MM-2001 PINSETTER

Fenix Service Bulletin Number MM-001

**Replacement of the elevator's metal straps***September 1997*

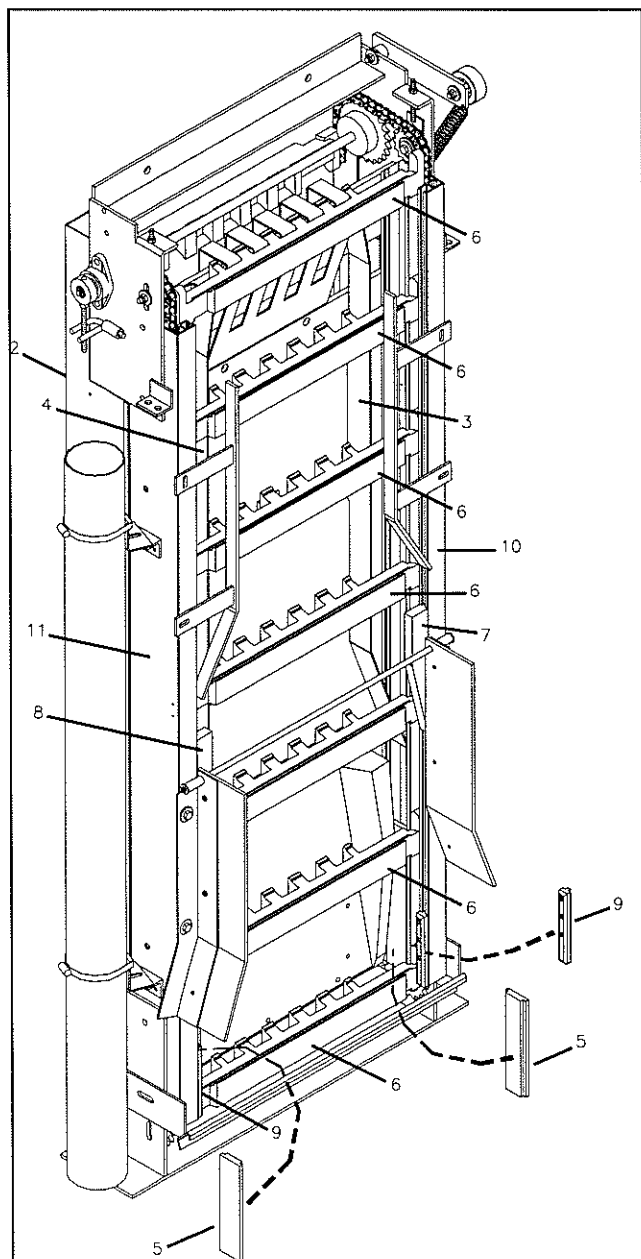
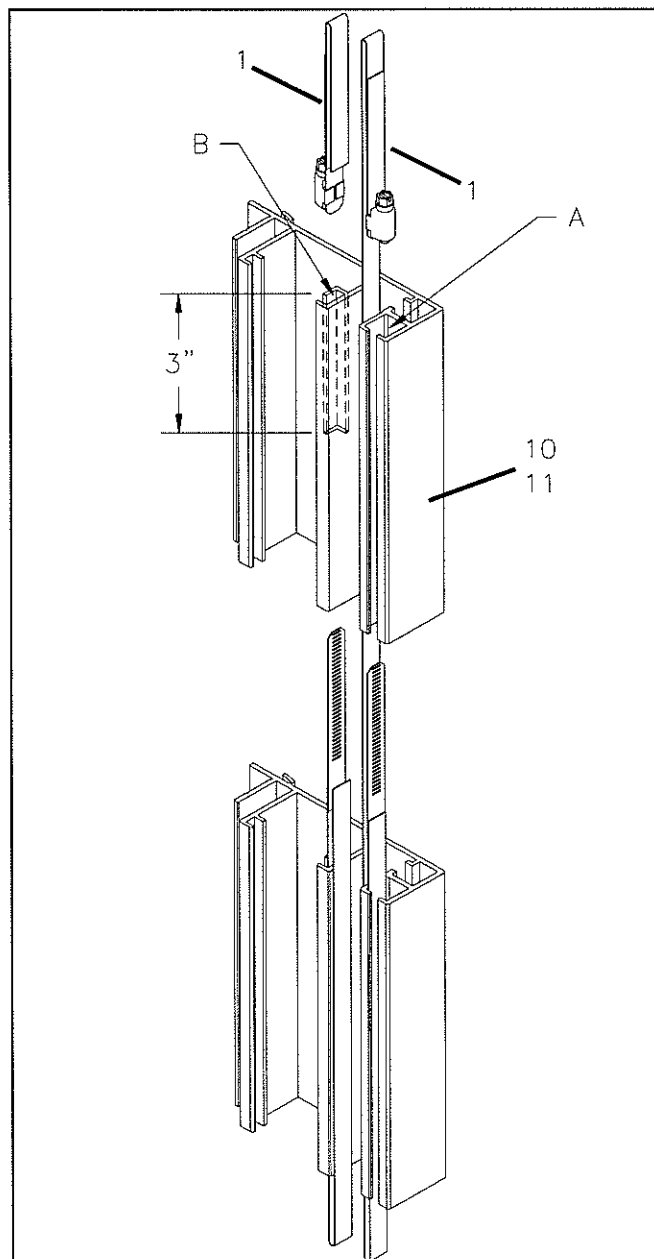
Subject to different degrees of friction from the pin lift arms (303-8020-00), the elevator's 4 metal straps (302-8005-00) may eventually wear and ultimately break. Although the pin elevator will function normally without these metal straps, it is important to replace them in order to protect the aluminum tracks from the constant movement of the drive chains. When replacing these metal straps, it is not necessary to replace all 4 at the same time. You may replace only the broken strap, but it should be noted that since this is not an easy procedure, you should take advantage of the fact that parts have been removed from the pin elevator. With these parts removed, you may want to verify the other straps and replace them if you judge that they too will break on a short-term basis.

Refer to **Figure 2** on the flip side of this bulletin in order to distinguish the difference between Groove A and Groove B.

If replacing the metal strap in Groove A, remove the following parts from the pin elevator (See **Figure 1**):

Once these parts have been removed, use a wood chisel to cut the elevator frame as indicated by the dotted lines in **Figure 2**.

- 1) Insert the metal strap (302-8005-00) into the groove from the bottom of the pin elevator as illustrated in **Figure 2**.
- 2) When the end of the metal strap reaches the top of the elevator, re-insert the interior wedge to its original position. (Do not tighten it in place at this point)

**Addition of the pin deviator***September 1997*

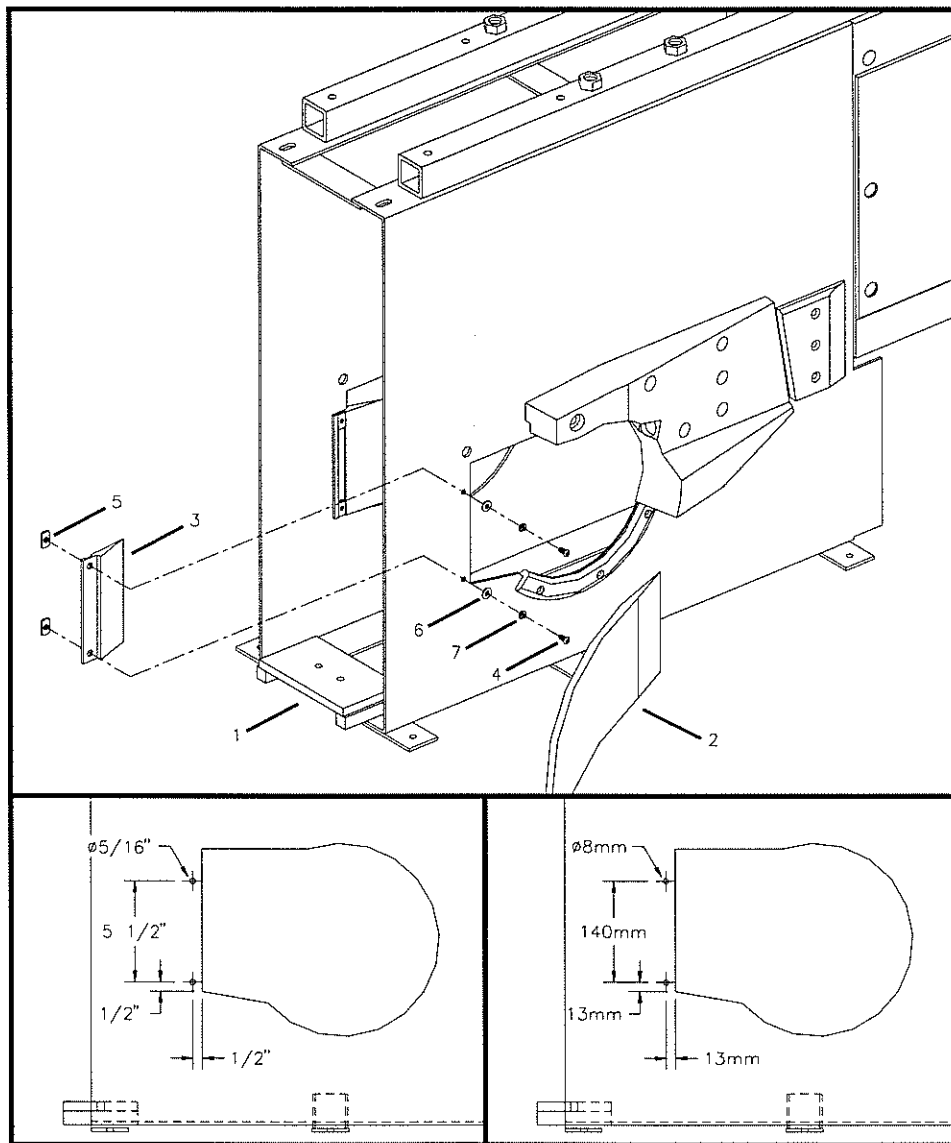
Starting with MM-2001 pinsetter serial number MMP-00717, pin deviators have been added to the back of the ball door opening. This measure was proven necessary in order to extend the life of the pit deflectors.

N.B. : When performing this modification, you **must** replace the 2 old pit deflectors with the 2 new pit deflectors included in the modification kit.

- 1) Remove the old pit deflectors (303-6330-00 & 303-6335-00).
- 2) Drill 2 holes in the metal kickback as indicated in **Figure 1**. Each of these holes must be 5/16"(8mm) in diameter.
- 3) Install the pin deviator (303-6570-00) inside the metal kickback and attach them in place using the hardware as indicated in **Figure 1**.
- 4) Install the new pit deflector (303-6300-00 & 303-6305-00) in the same position occupied by the old ones which were removed in step 1.

**Modification of the pit conveyor belt tensioner***September 1997*

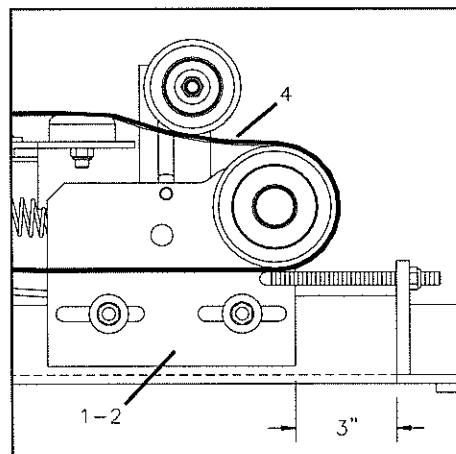
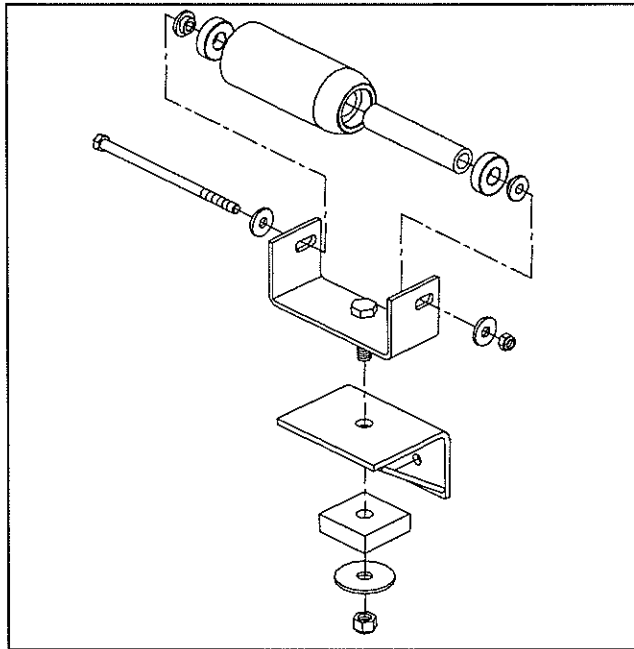
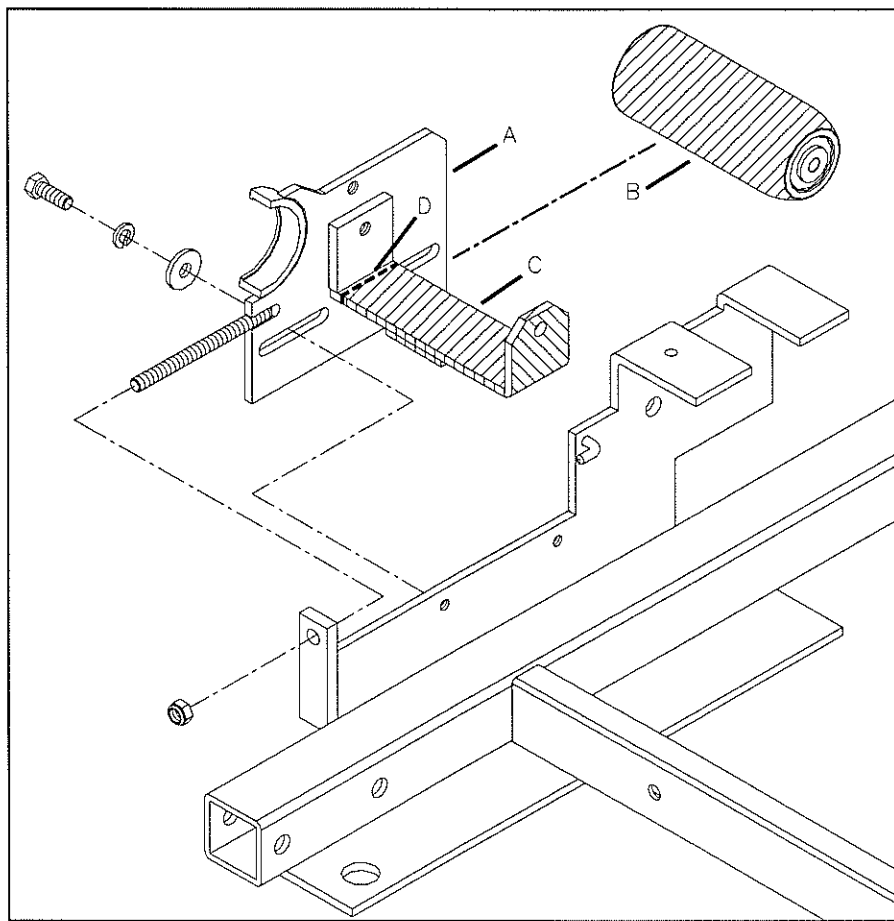
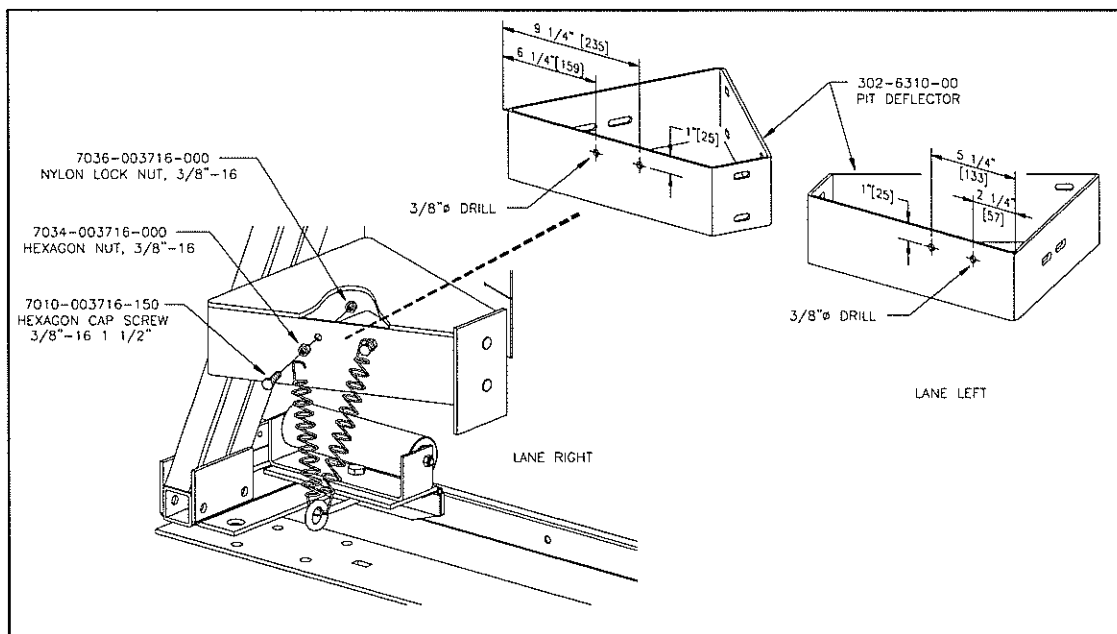
The pit conveyor belt tensioner has been modified in order to facilitate its adjustment. This modification was introduced with serial number MMP-00695.

Adjust the tensioner to have a distance of 3" between the pit frame (302-6000-00) and the tension plate (302-6030-00...302-6045-00) on both sides. Start the main motor (MENU-IO-OUTPUT-220VT-MAIN MO.-SET ON). Place a 6 pound ball on the conveyor belt on the opposite side of the ball return. Remove the tension on the pit conveyor belt (ball return side) until the ball moves toward the ball door easily on its own. Once this side is done, take the measurement between the pit frame and the tension plate on this side and place the other side at the same measurement.

THE DISTANCE FROM THE PIT FRAME AND TENSION PLATE SHOULD ALWAYS BE MAINTAINED BETWEEN 3" AND 3-3/8".

- 1) Remove the old tensioner located on the opposite side of the ball return and bolt the new one in place using the same hole.
- 2) Go to step 7 (page 4).

- 3) Remove the old tension plate "A" located on the opposite side of the ball return, remove the roller "B" and cut the bottom flat bar "C" as indicated by line "D" on the plan.
- 4) Re-install the tension plate in place (without the roller "B").
- 5) Tighten the new tensioner in place with one hexagon cap screw, adjust the roller to be exactly at the same level as the conveyor roller (302-6050-00 / 302-6075-00).
- 6) Drill the second hole for the tensioner and tighten with the other hexagon cap screw.

- 7) On the odd lane, drill 2 holes in the pit deflector (302-6310-00), one at 5 1/4"(133mm) and the other at 2 1/4"(57mm). These two holes must be 1"(25mm) from the top of this part.(figure 4)
- 8) On the even lane, drill 2 holes in the pit deflector (302-6310-00), one at 6 1/4"(159mm) and the other at 9 1/4"(235mm). These two holes must be 1"(25mm) from the top of this part.(figure 4)
- 9) Install the 2 hexagon cap screws and the hexagon nuts from the outside, and tighten with the nylon lock nuts from the inside.
- 10) Install the 2 springs on the tensioner. Do not overextend the springs.
- 11) Install the guide wheel (303-6070-00) on top of the conveyor roller (302-6050-00 / 302-6075-00) to keep the conveyor belt from touching the metal frame of the pit.

**Replacement of the deck cover***October 1997*

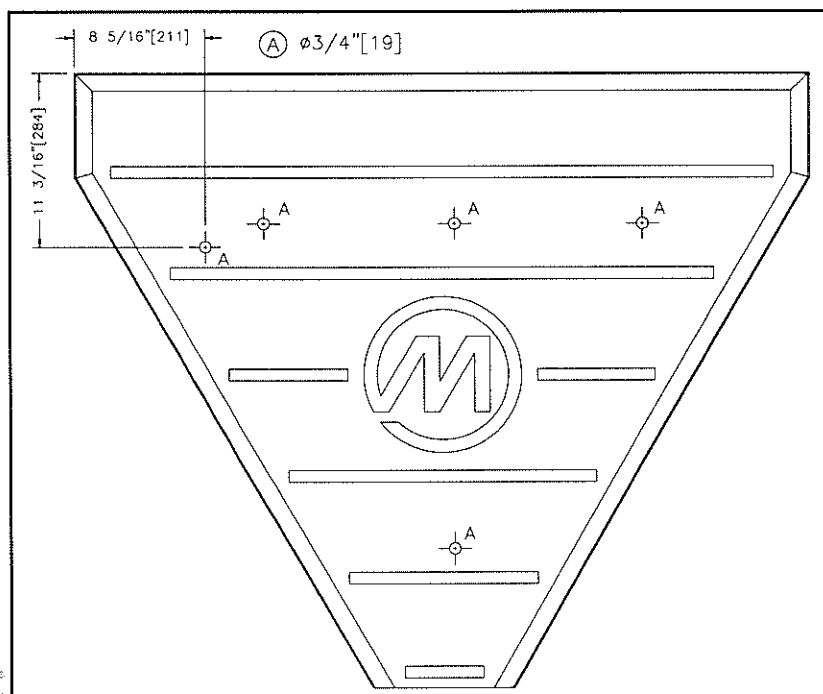
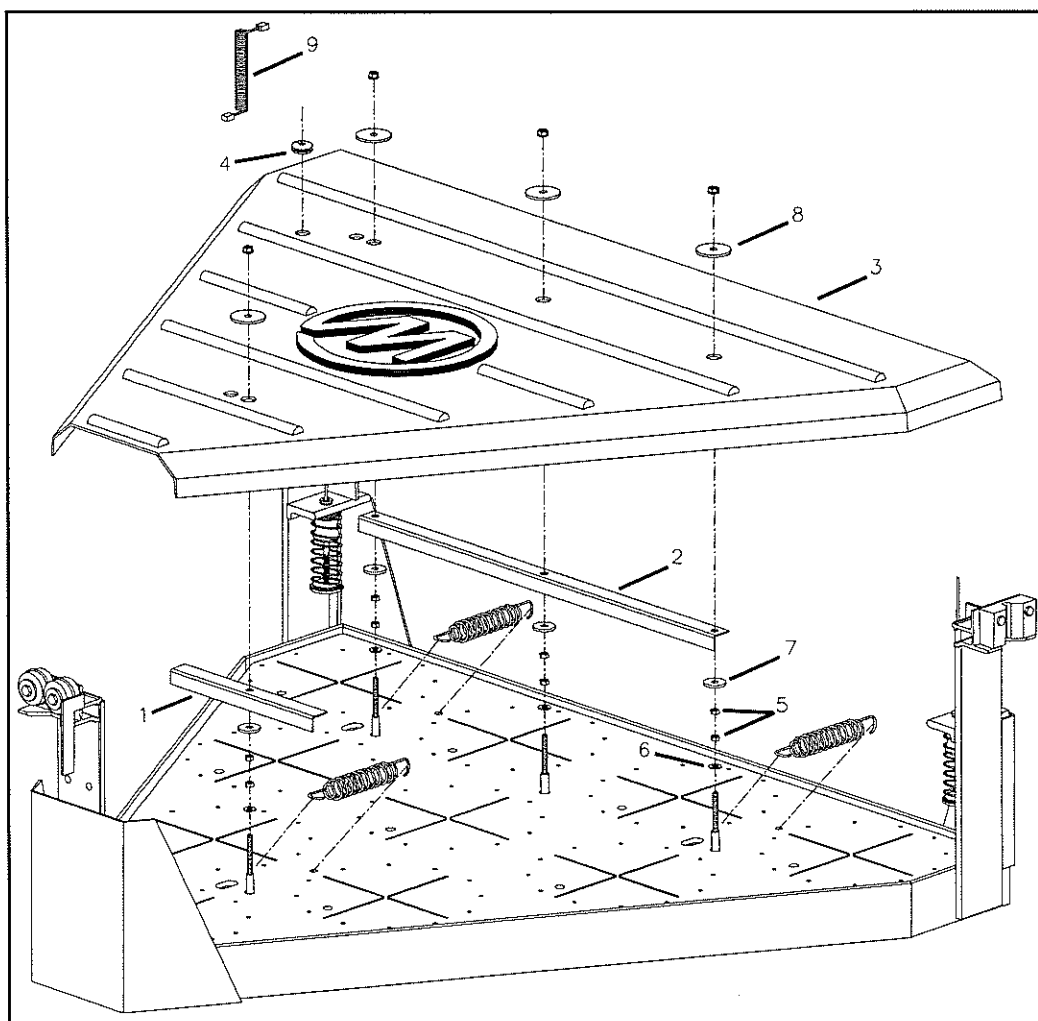
Starting with MM-2001 pinsetter serial number MMP-00755, new support brackets have been added to the deck cover (303-1520-00). The design of the deck cover has not changed, these new supports are 100% compatible with the older pinsetter. This measure was implemented in order to solidify the deck cover and protect it from the impact of foreign objects falling on it.

For the installation of the deck cover with the new support, you will need to order the deck support modification kit # 399-1505-00. All the parts listed in **Figure 2**, with the exception of these 3 items (303-1520-00, 304-1580-00 and E-PH113-14), are included in the modification kit.

- 1) Enlarge the existing holes and drill an additional one as shown in figure 1. All 5 holes are to have a diameter of 3/4" (19mm).
- 2) Remove the out of range cable (E-PH113-14) and the deck grommet (304-1580-00) and re-position in the new hole which was drilled in step 1.
- 3) Follow the plan in Figure 2 to re-install the deck cover and its components.

**Replacement of the Elevator Pin Lift Arm.**

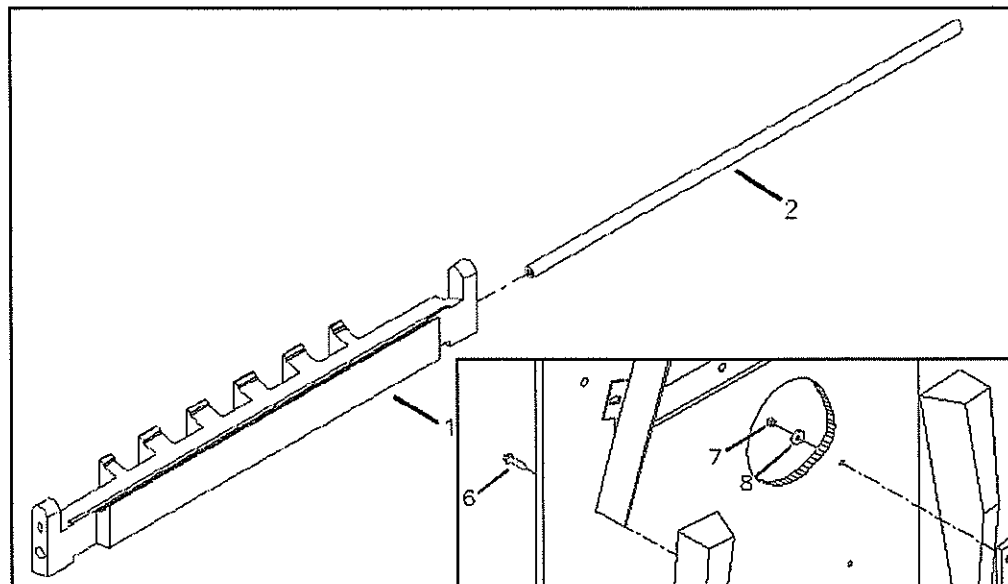
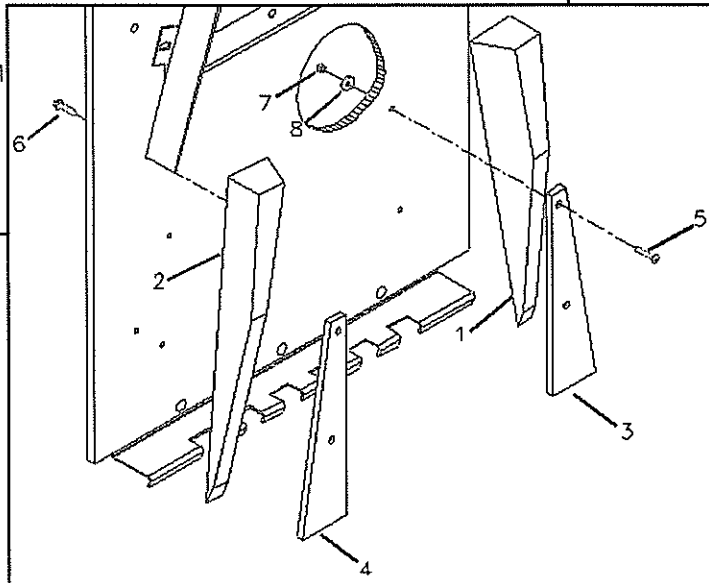
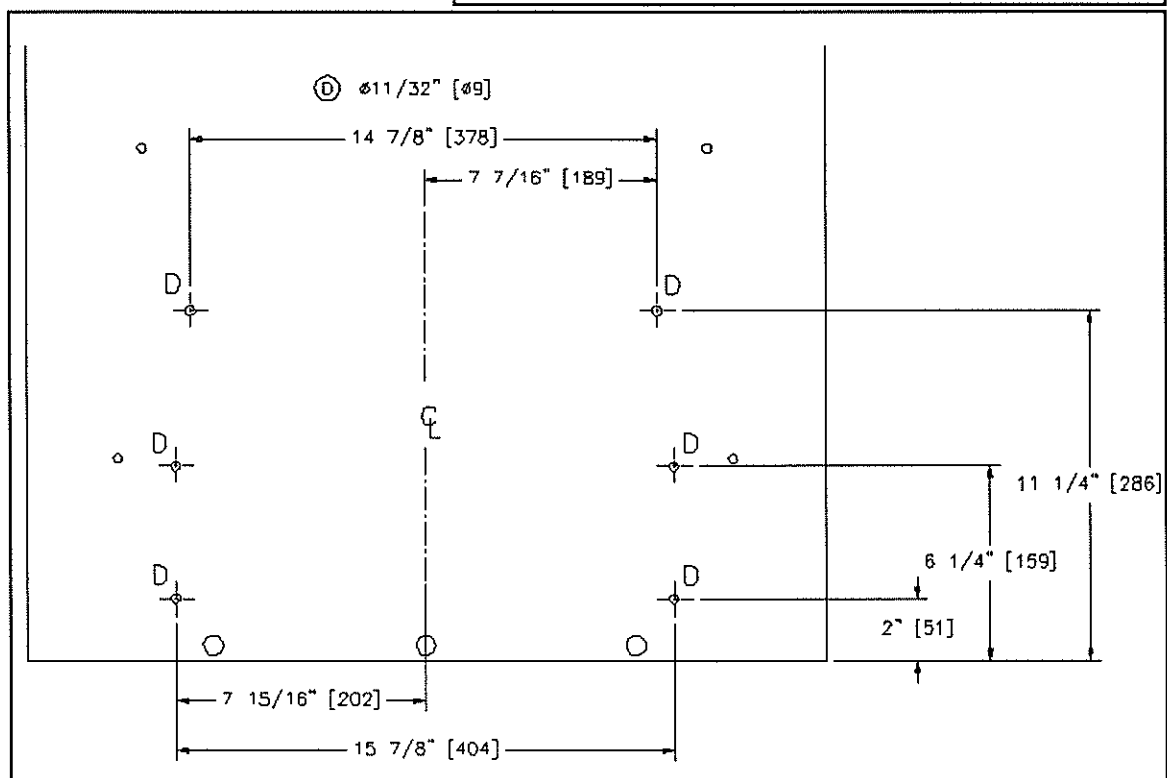
New Model (Black): For all the pinsetters with a serial number equal or superior to MMP-0298, the pin lift arm (303-8020-00) is made of black urethane and require a Support Rod (302-8340-00). (**Figure A, Item 1 & 2**)

N.B.: When you order a black Pin Lift Arm to replace a white Pin Lift Arm, you have to order a Support Rod (302-8340-00) for each of the black Pin Lift Arm ordered.

- Installation of an Interior Wedge Right (303-8220-00) and an Interior Wedge Left (303-8225-00). (**Figure B, Item # 3 & 4**)

Both of these Wedges are installed on the inner side of the elevator (towards the pinsetter) and must be bearing on the Interior Block Right (303-8070-00) and Left (303-8075-00). (**Figure B, Item # 3 & 4**)

- **Figure C** is showing the position and size of the hole to be drilled in the Interior Panel Bottom (303-8045-00).
